LAW OFFICE OF HOWARD CRYSTAL

April 22, 2016

Re: Docket ID NRC-2011-0148: Scoping Comments For Proposed Expansion Of
Ross In Situ Uranium Recovery (ISR) Project To Include The Kendrick
Expansion Area (License SUA-1601)

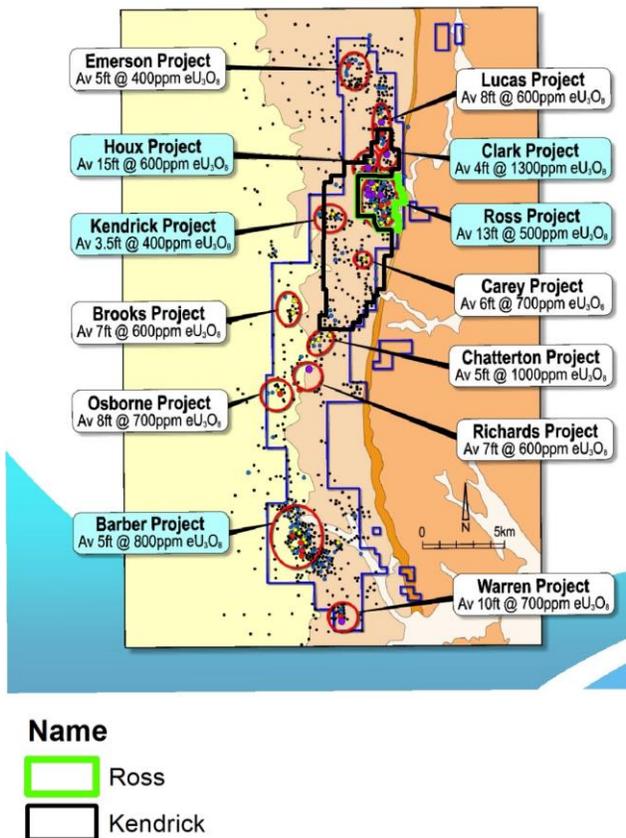
As the Organizations explained in challenging the segmented scope of the Ross Project SEIS, the Commission was required by NEPA and implementing regulations to prepare a single, comprehensive EIS that considers the environmental impacts of SEI’s plans for ISL mining throughout the Lance District, including not only the initial Ross Project and the Kendrick Expansion, but also Richards and Barber areas. Indeed, it has long been evident from Peninsula Energy public documents and statements that SEI will inevitably be developing *all* of these areas. *See, e.g.* Figure 1 below.

All of the projects depicted in Figure 1 are reasonably foreseeable and have been proposed by SEI as expansions of its original Ross Project. They are adjacent to each other in geography and connected via a central processing facility. They are also connected via watersheds, aquifer systems, mineral-bearing formations, ingress and egress roads, and any number of areas whose connection directly bears on the full scope of the impacts.

Figure 1: Lance Projects Pre-Production Drilling Location

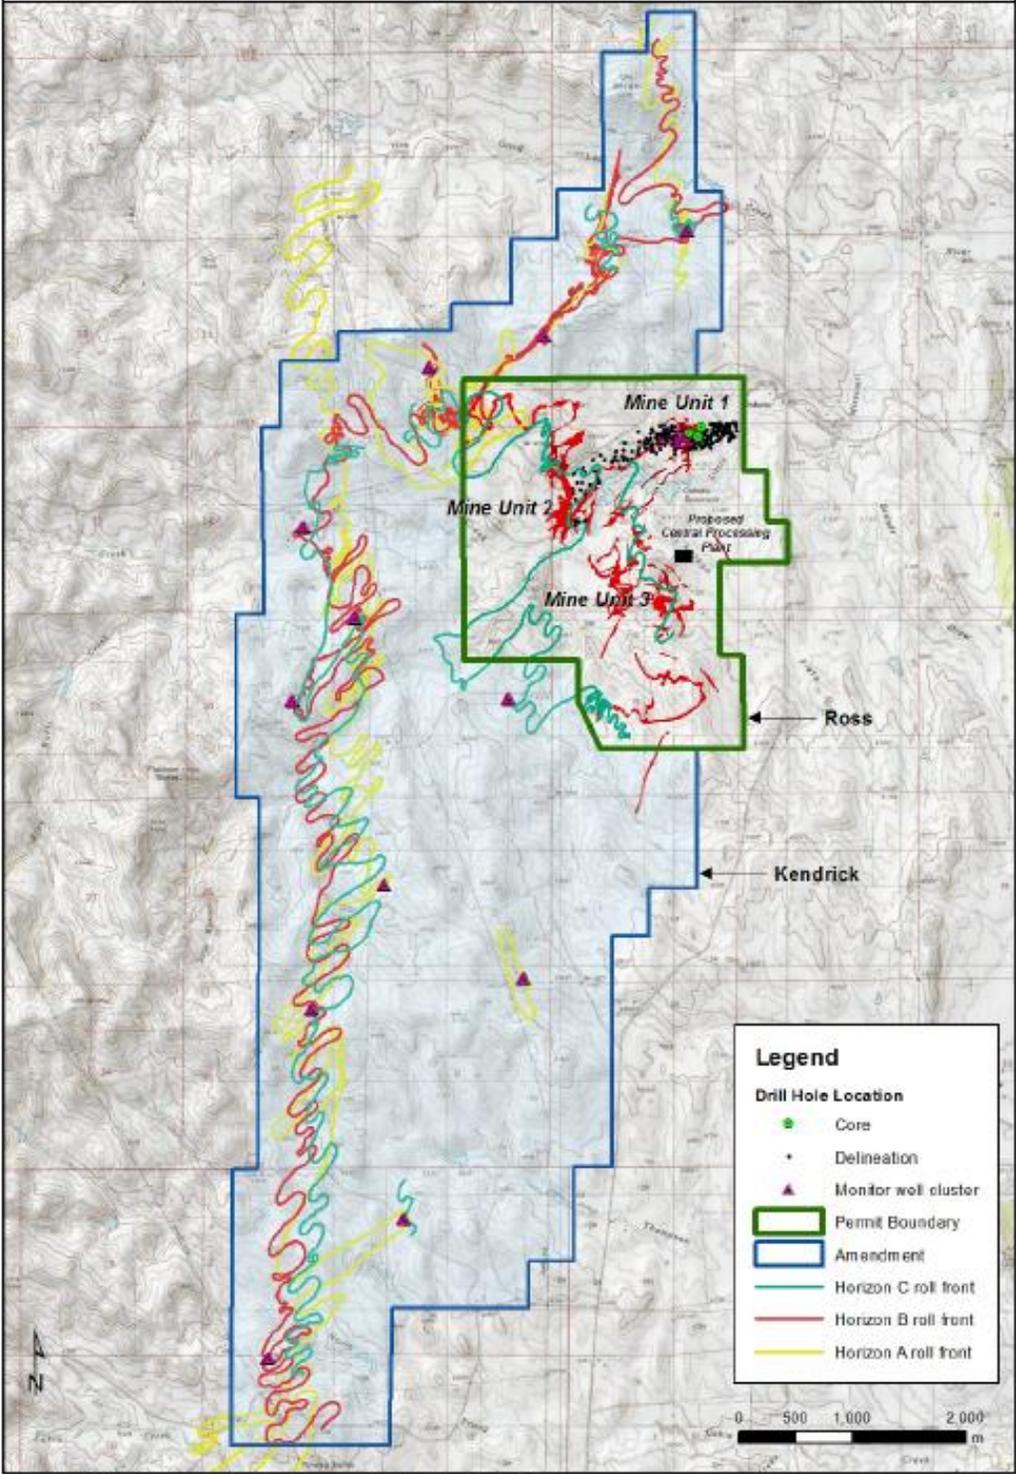
27. As shown in “Figure 1: Lance Projects Pre-Production Drilling Location” on the next page, the Kendrick “Amendment” Area (in light blue) surrounds the Ross “Permit” Area (green border) on three sides and dwarfs it in size, but it is not included within the scope of the FSEIS “Proposed Action.” (Source of figure is the same release cited in 26 above)

Detail from the March 21 Peninsula Presentation to the “2013 Mines and Money Conference”

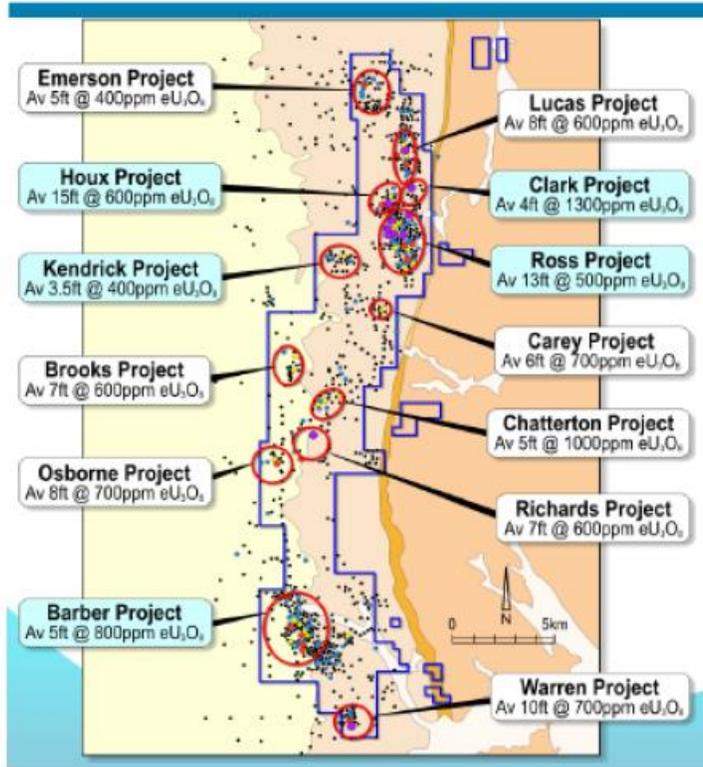
32. The FSEIS does not include an analysis of the environmental impacts of changes in lixiviant chemistry that could lead to such a dramatic *67% increase in the rate of mineral extraction* above what was assumed for the Ross Project impact analysis, much less the effects of its wider application to the much larger subsurface areas represented by the

Kendrick and Barber Production Units, and subsequent production areas of the Lance District. (For the latter, see PD1 at 53.)

Peninsula Energy Ltd. Hong Kong “Mines and Money” Conference, 2014 Company

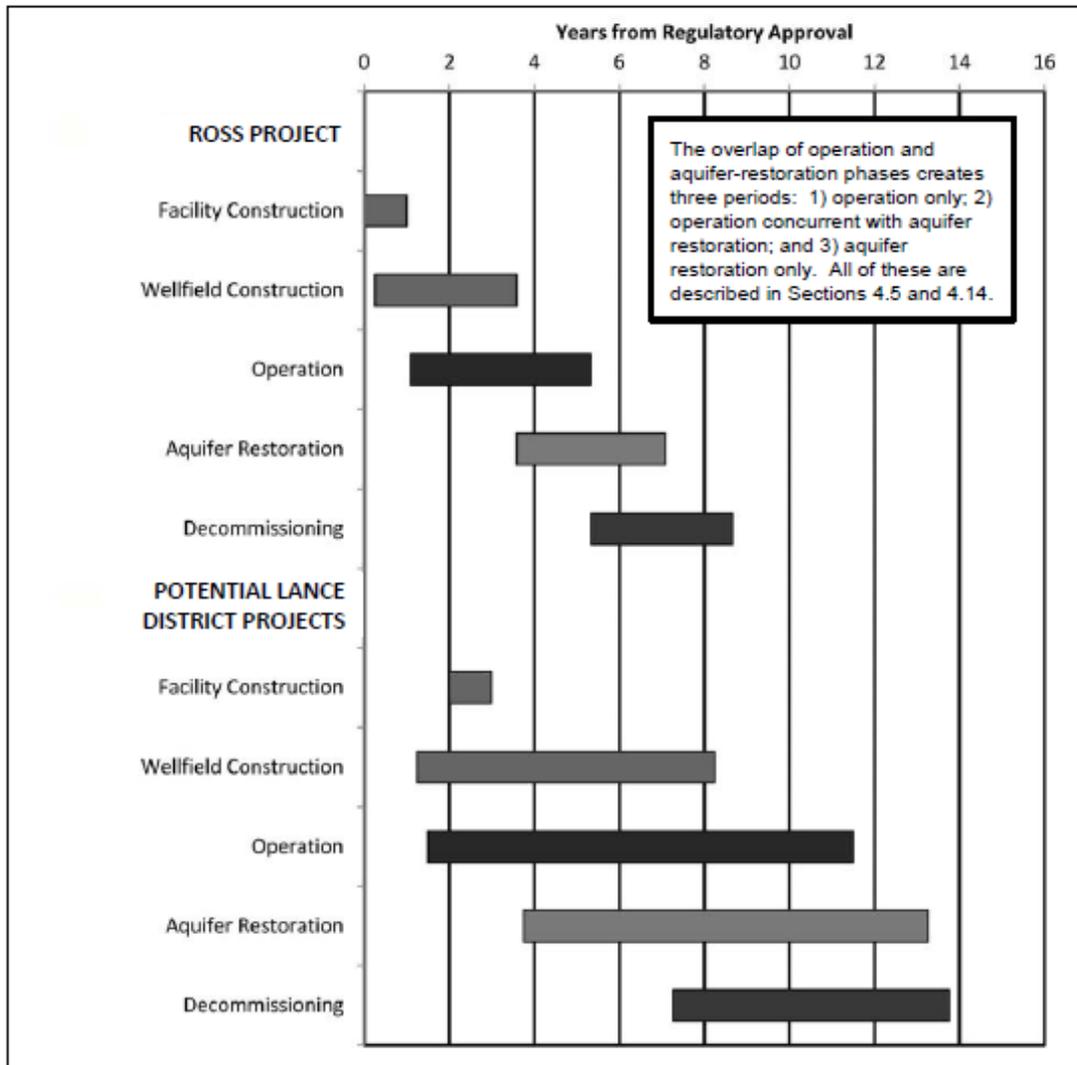
46. Peninsula recently summarized these mining plans in its 2014 “Mines and Money” conference presentation as follows:
